Carolina Power & Light Company

OG-137  
Ref: OG-110,  
12/1/83 &  
OG-117  
3/9/84  
October 25, 1984

Westinghouse Owners Group  
Program to Address Generic Letter 83-10 - RCP Trip  
Response to NRC Questions

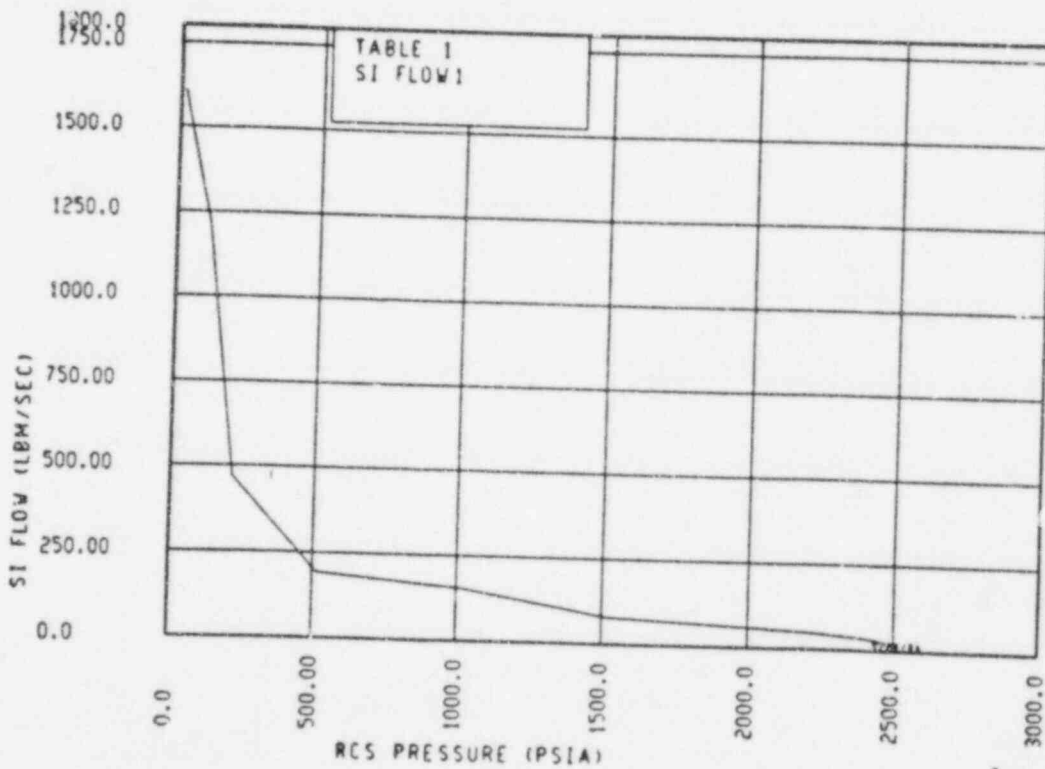
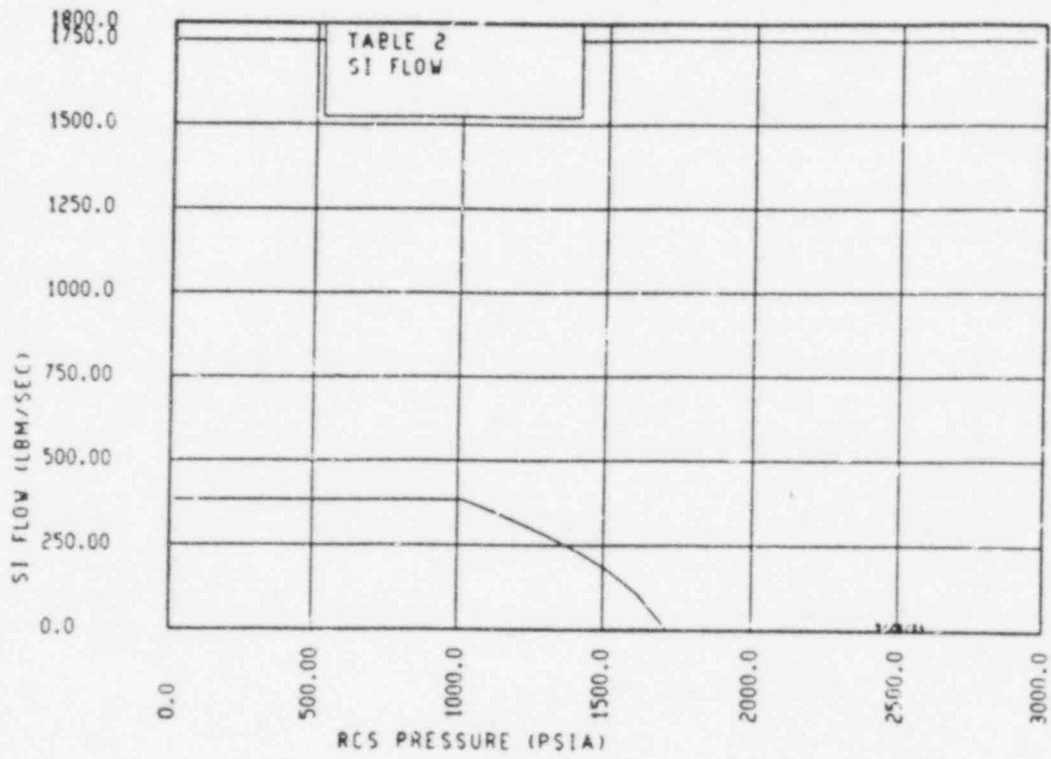
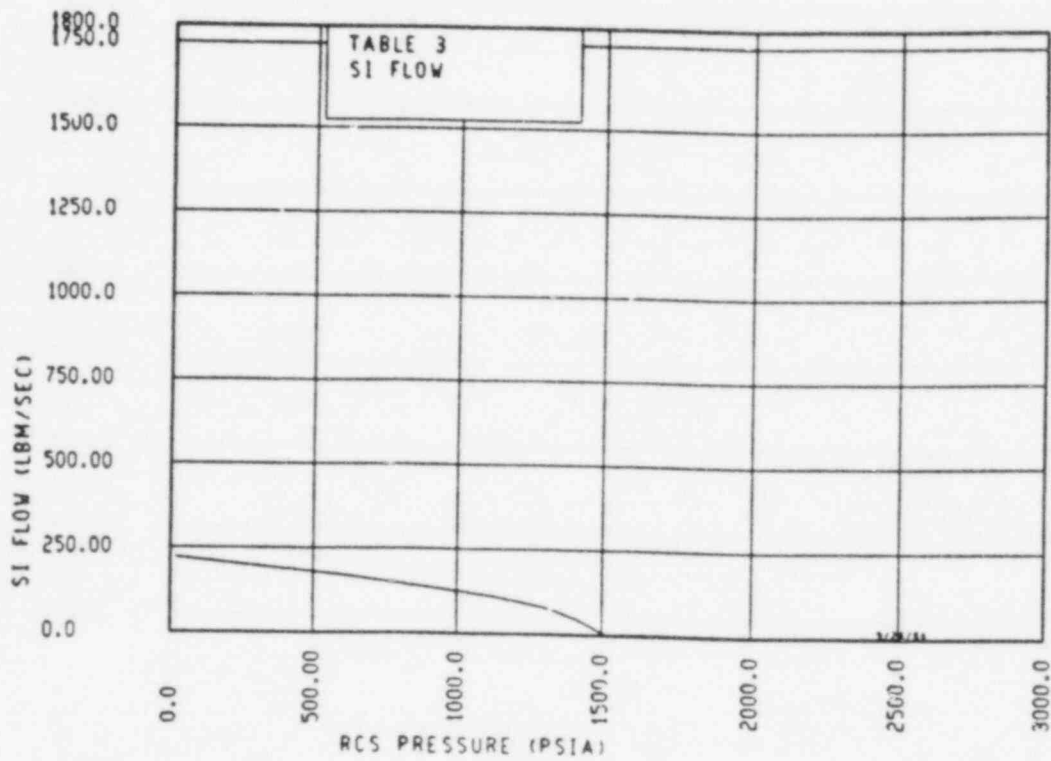
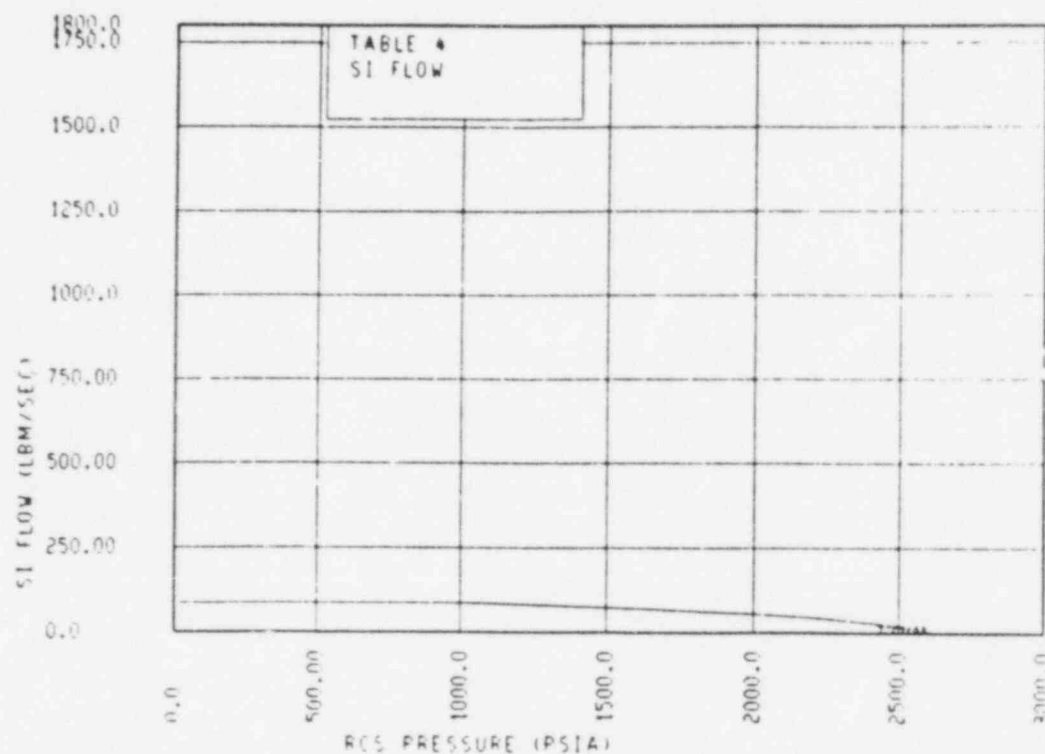
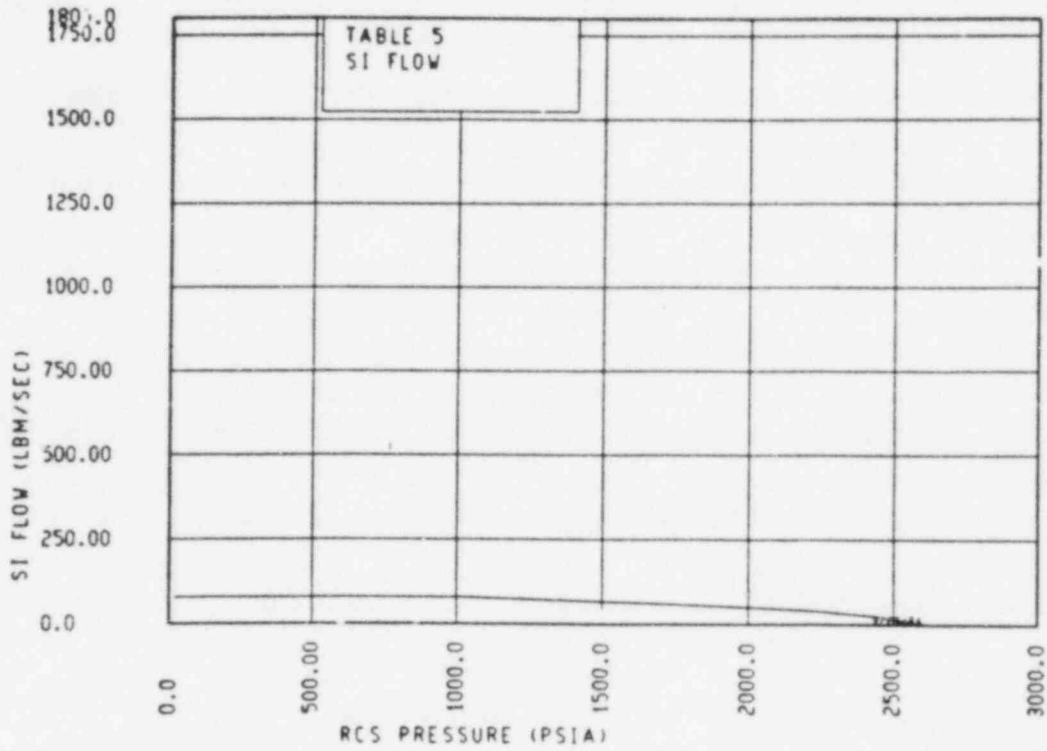
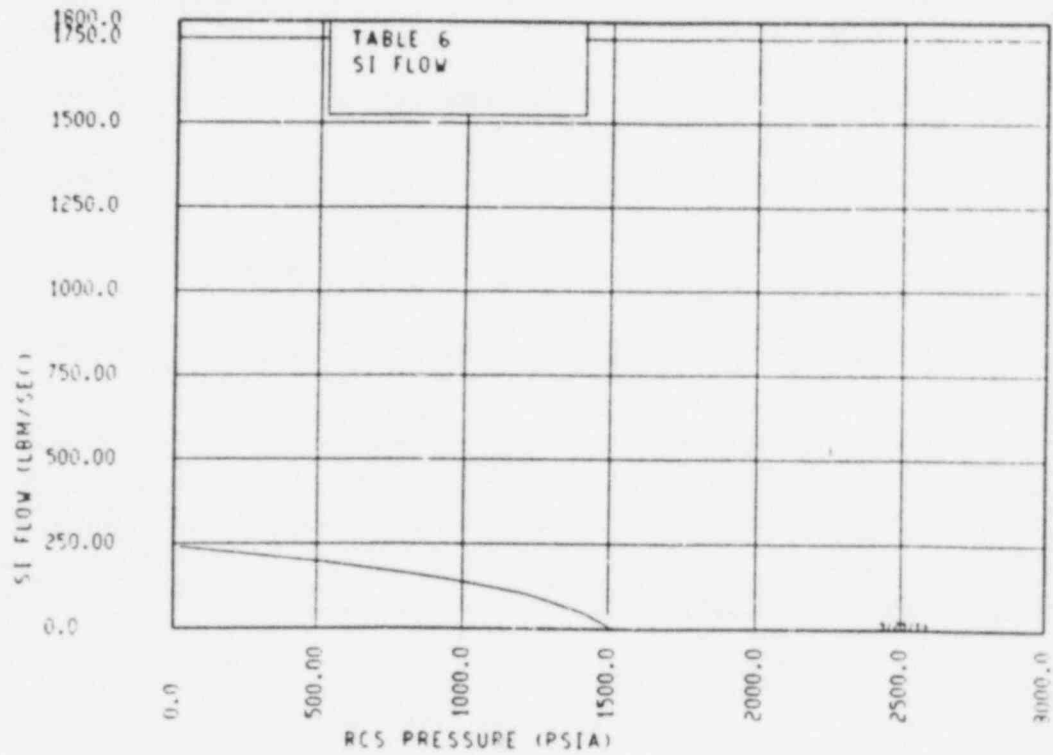
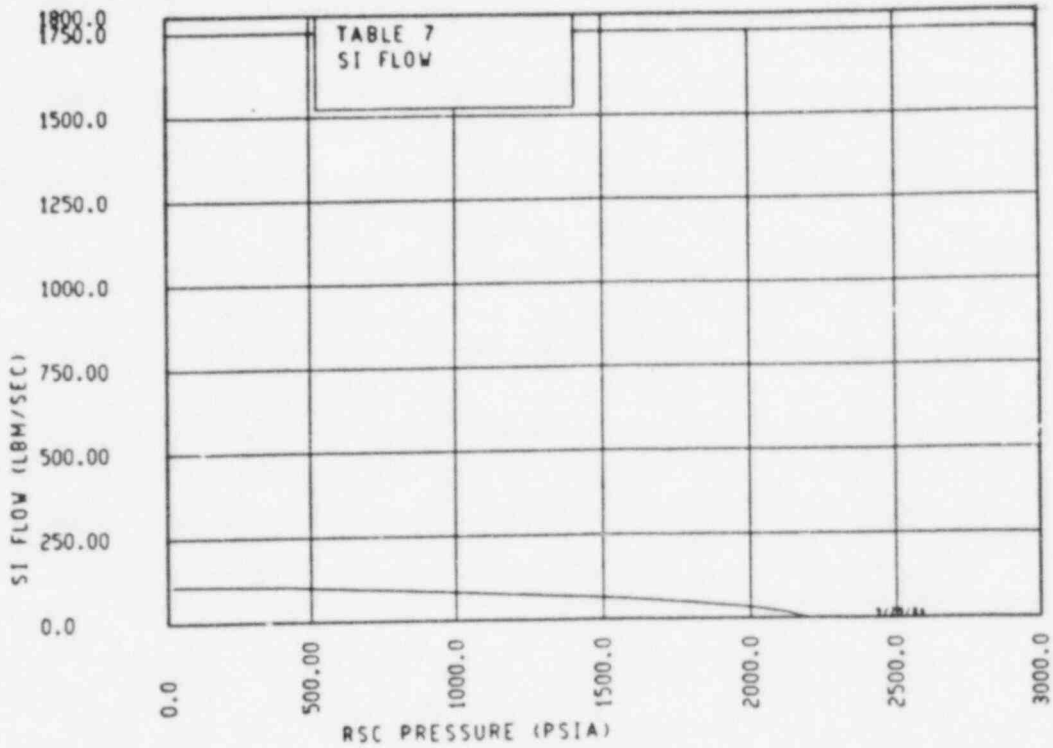
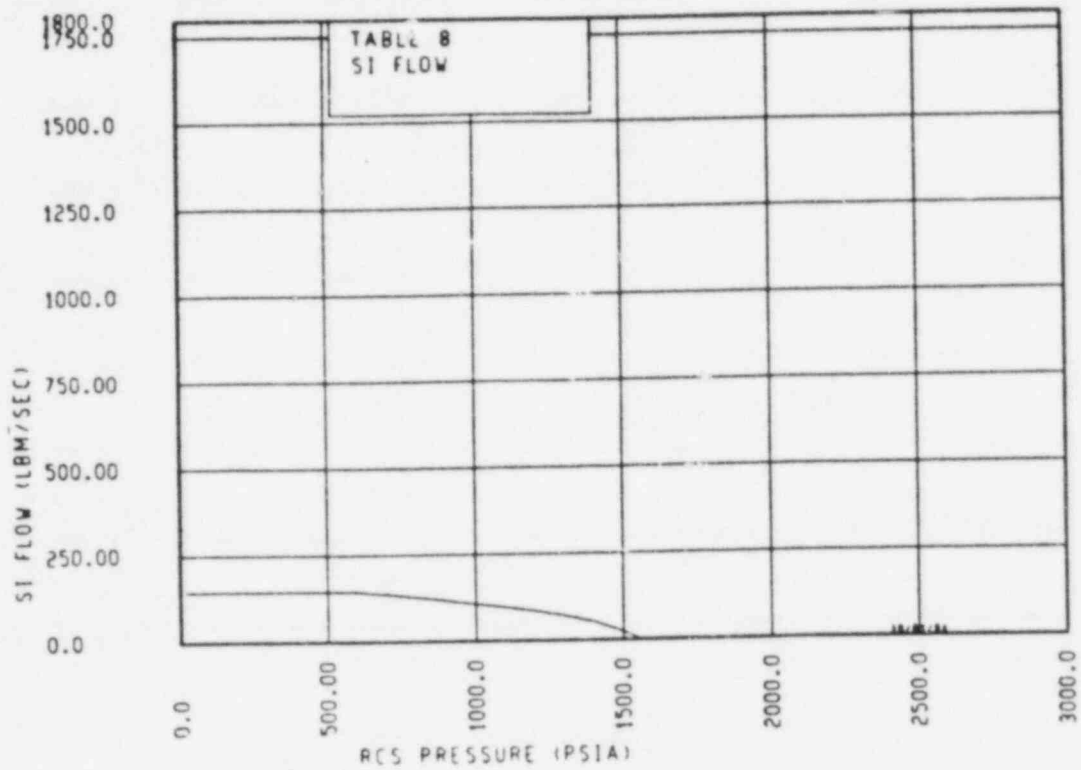
- Q.24      What SI flow rates were used for each category?
- Q.25      What auxiliary feedwater flow rate was used and was one selected for each grouping of 4-, 3-, and 2-loop plants or was the same one used for all of them?
- A.24-25    The SI flow rates and auxiliary flow rates used in the SGTR analysis are shown for each plant category in Tables 1 through 8.

Void Fraction Of Node Supplying Break

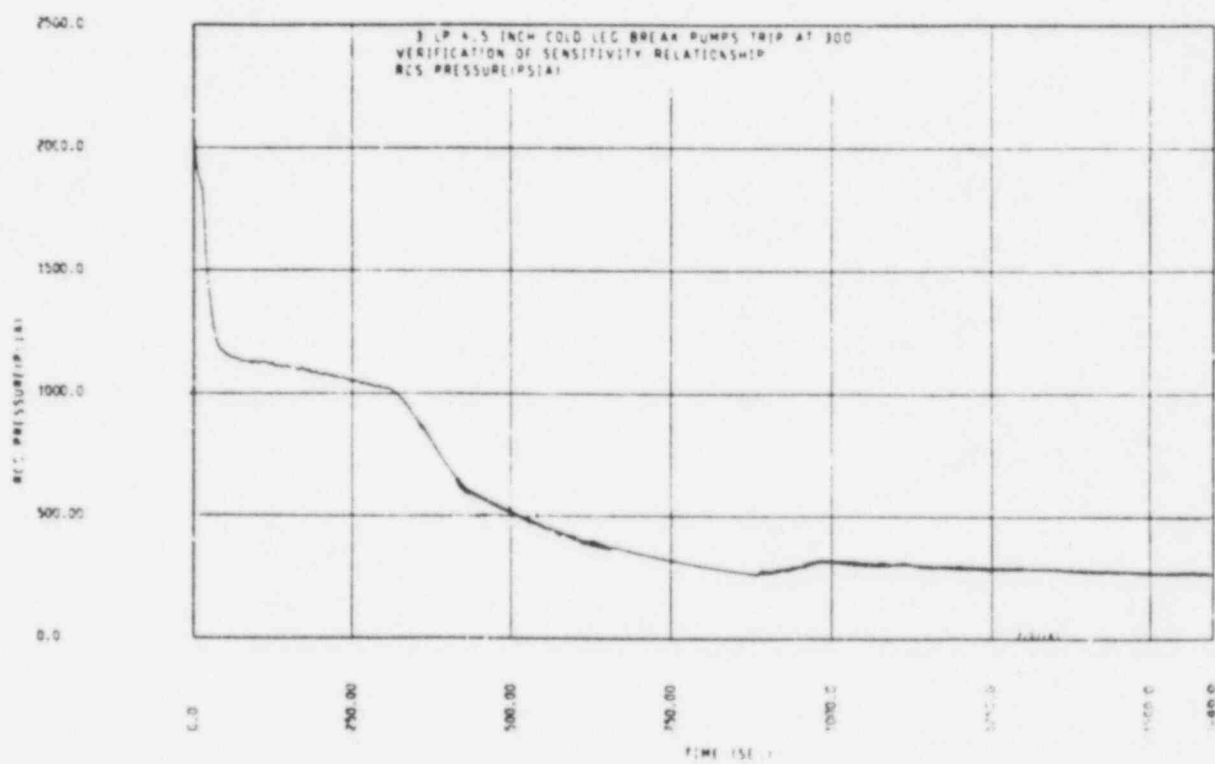
Q.43 What is the void fraction vs. time supplying the break for the pumps on case?

A.43 See the attached figure.
